<b>Subject:</b>  NOISE FROM FRONT DOOR CHECKER AREA	<b>Bulletin No:</b> 09-005/15
	<b>Last Issued:</b> 02/04/2015

## BULLETIN NOTE

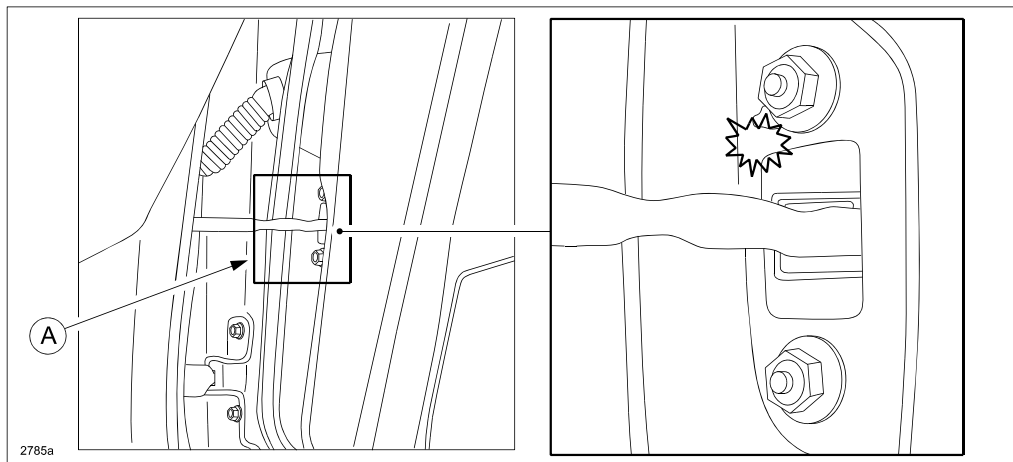
Some vehicles may experience noise from the front door checker installation location (A) whenever the door is opened. When the door is fully opened, the door checker may become over-stroked and cause a crack at the spot welding area around the door checker.

To eliminate this concern, the thickness of the hinge reinforcement has been increased.

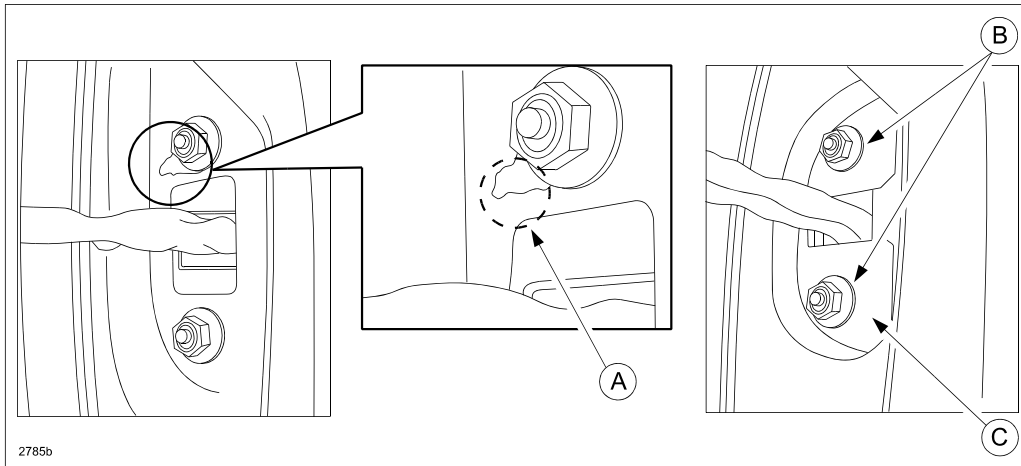
1. Verify the customer concern.
2. Inspect the body panel welding point (A) on both front doors.
  - If no cracks are found on the body panel, this service bulletin does not apply. Refer to the online instructions on MS3 or the Workshop Manual (Section 09 - Body and Accessories) for further troubleshooting.
  - If the body panel is cracked, repair it according to the steps below:

- a. Apply approx. 0.3 ml grease per side (using either molybdenum grease or lithium grease) on the welding point (A) (cracked area).
- b. Install plate (C) (checker reinforcement) on the body panel.  
**Tightening Torque (B): 71-106 in•lbf {8-12 N•m, 82-122 kgf•cm}**
- c. Repeat the repair on opposite side front door.

- a. Remove all corrosion found on the body panel.
- b. Apply primer to the repaired surface.
- c. Apply touch up paint to the repaired surface.
- d. Install plate (C) (checker reinforcement) on the body panel.  
**Tightening Torque (B): 71-106 in•lbf {8-12 N•m, 82-122 kgf•cm}**
- e. Repeat the repair on opposite side front door.
